Flight Procedures Cover Page	Task Action: FLIGHT CHECK	Task Type: IAP	Estimated Chart Date: 02/20/2025	APWS Task ID: DEF124A6BD9347FBB7F8B19530AF1B29	APWS Project ID: 83E84B1038724062B7ACB9EFCAE33B40
Procedure: RNAV (GPS) RWY 23 AMDT 2		Enroute: NO	Specialist: Wilkinson, Christopher		Agreement Number:
Airport ID: KFMY			Airport City: FORT MYERS		State: FL
Facility ID:	Facility Type:	Flight Inspection Remark Type: New FC Slot			
<div>Procedure Comments:</div> <div>UTILIZED PENDING DATA (10/31/2024) FOR KFMY AND RUNWAYS.</div> <div>VOR MON: Lbv VORTAC REMOVED FROM PROCEDURE, REPLACED IAF SEGMENT.</div> <div>GS/TCH ALIGNED WITH VGSI.</div> <div>CRC REMAINDER CHANGED FROM 7C5AF1AC TO 8C12BADB.</div> <div>CONTACT: JOSEPH ZEDER, AJV-A430, (405) 954-9111.</div> <div>QUALITY 9 CHECKED BEGUE</div> <div>QUALITY 35 CHECKED</div>

FIPC BASIC FORM									
PROCEDURE: RNAV (GPS) RWY 23 AMDT 2				AIRPORT NAME: PAGE FLD		AIRPORT ID: KFMY		SPECIAL CONTROL NO: AG-11-156-24	
FAC ID: KFMY23.02			CITY: FORT MYERS			ST: FL		ORIG CHART DATE: 02/20/2025	
DFL TYPE: PROC/S		THIRD PARTY: <input type="checkbox"/> YES		EST. TIME ON SITE: 0.4		REIMB. NUMBER: AC0721		PTS TASK ID: DEF124A6BD9347FBB7F8B19530AF1B29

RNAV (GPS) RWY 23

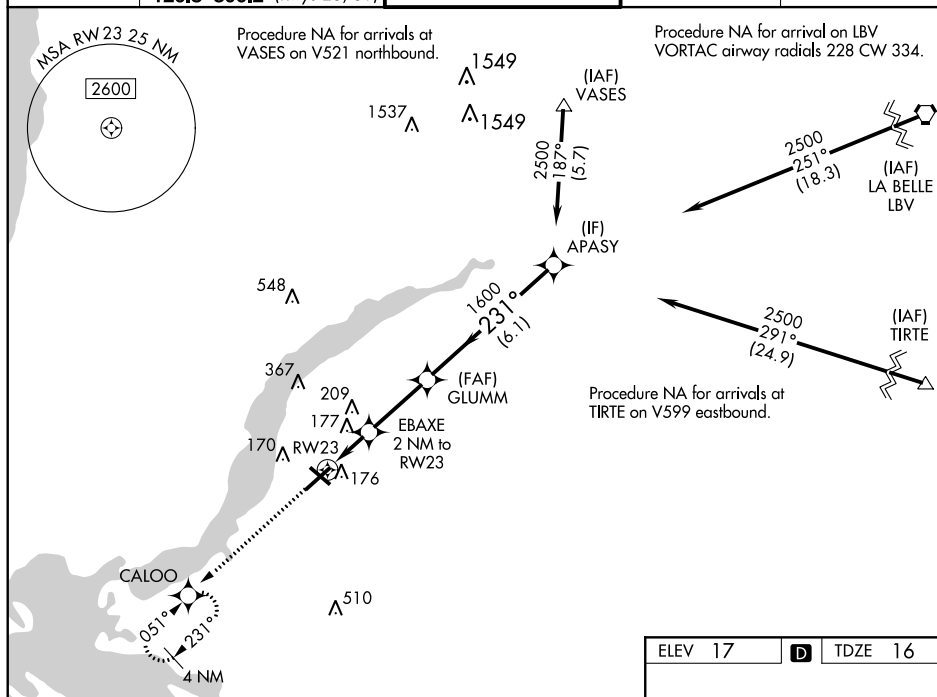
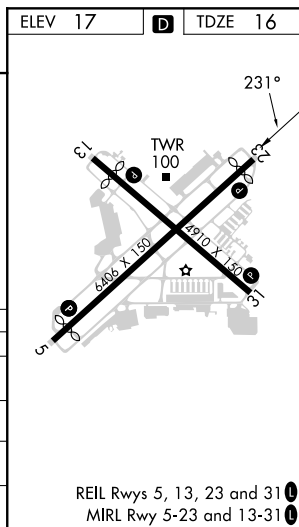
FLIGHT INSPECTOR SIGNATURE: michael c mccurdy @ 12/19/2024 09:27				PRINTED NAME: MCCURDY, MICHAEL CURTIS				NOTAM INITIATED? <input type="checkbox"/> YES <input checked="" type="checkbox"/> NO	
FLIGHT INSPECTOR REMARKS: Sat with changes. Change FIG to show LPV minima of 278 - 7/8 per 8260-3.									
IN-FLIGHT OBSTACLE REPORT									
OBSTRUCTION ID #:		COORDINATES OR LOCATION:		GNSS ALTITUDE (MSL):		BAROMETRIC ALTITUDE (MSL):		HEIGHT ABOVE GROUND LEVEL:
